**STATE OF HAWAII
DEPARTMENT OF TRANSPORTATION
HIGHWAYS**

**ADDENDUM NO. 1
FOR
KAUMUALII HIGHWAY DRAINAGE IMPROVEMENTS
VICINITY OF OMAO STREAM BRIDGE
DISTRICT OF KOLOA
ISLAND OF KAUAI
FEDERAL-AID PROJECT NO. ER-27(008)**

October 22, 2026

STATE OF HAWAII
DEPARTMENT OF TRANSPORTATION
HIGHWAYS DIVISION
**DRAINAGE OUTLET
PLAN AND PROFILE**
KAUMUALI'I HIGHWAY DRAINAGE IMPROVEMENTS
VICINITY OF OMAO STREAM BRIDGE
Federal-Aid Project No. ER-27(008)

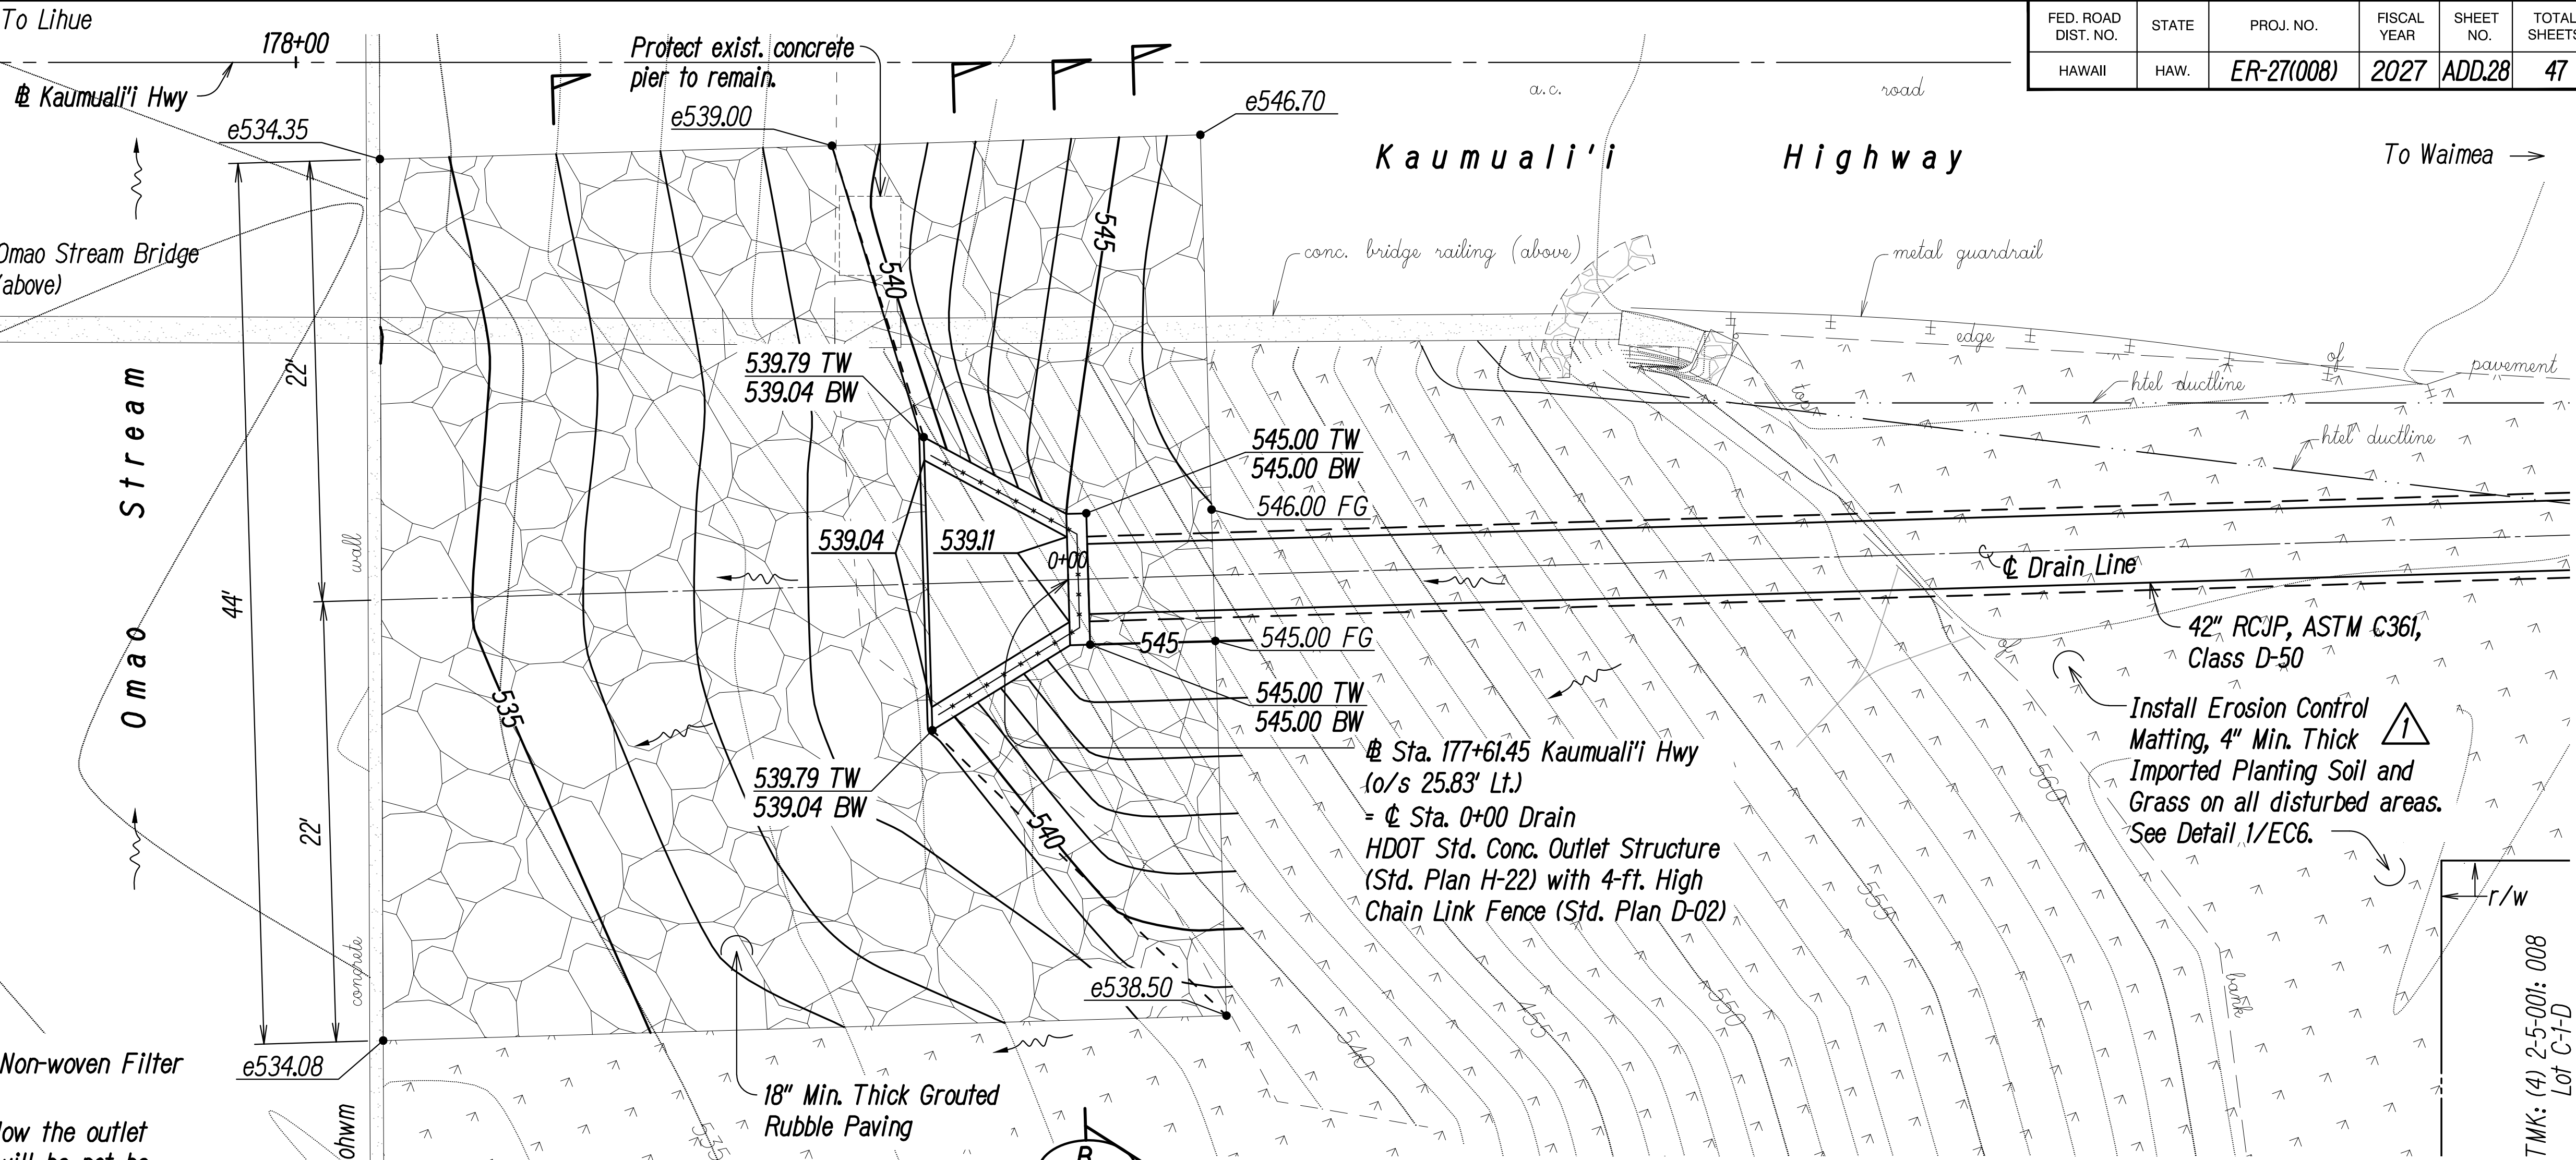
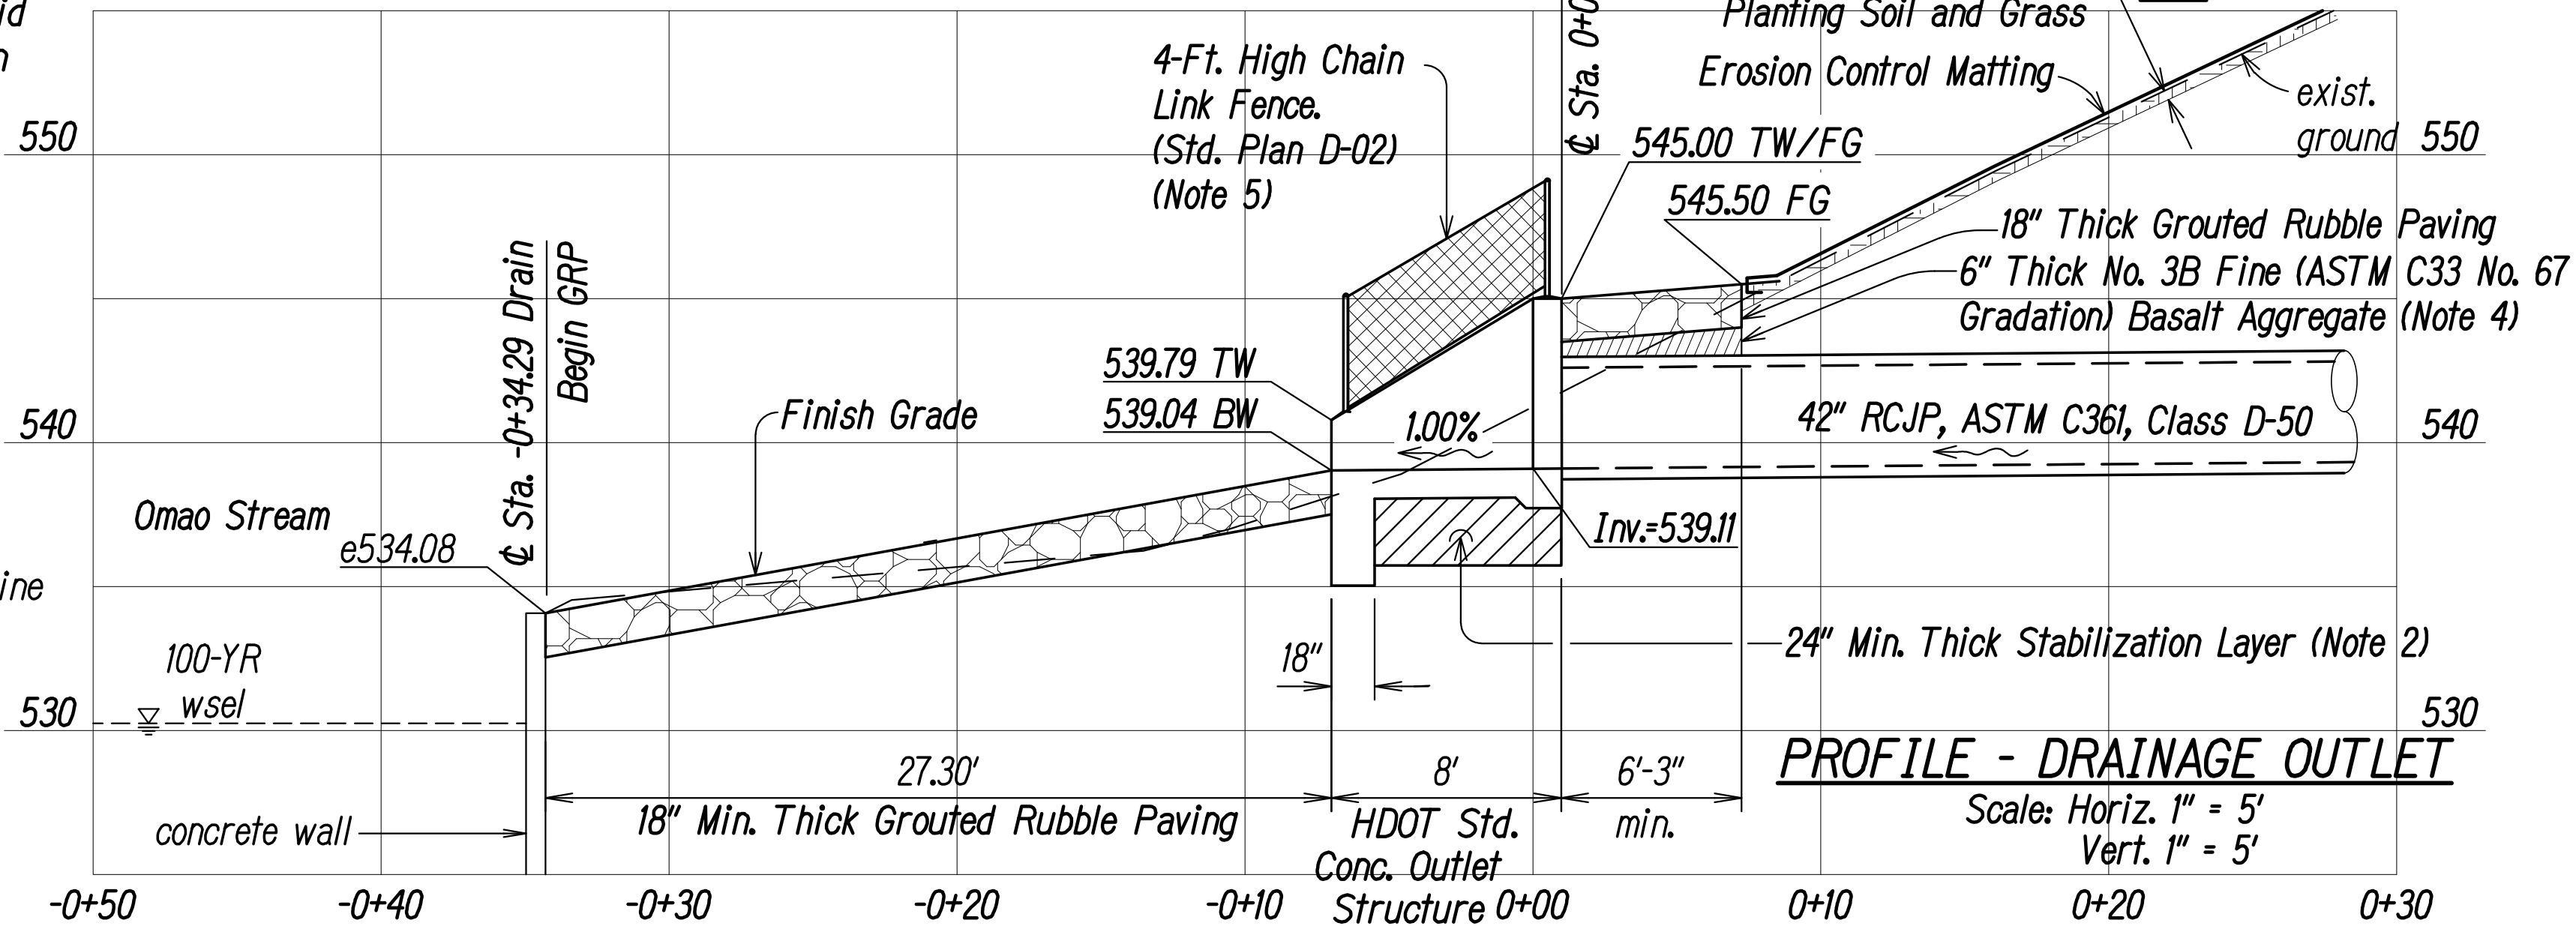
10/22/26 Revised plan and profile to show 4" thick imported planting soil and grass on disturbed areas. Added note 6.

- Topsoil to be paid under Item No. 617.0100 Imported Planting Soil (4" Layer). Grass to be paid under Item No. 641.0100 Hydro-mulch Seeding.
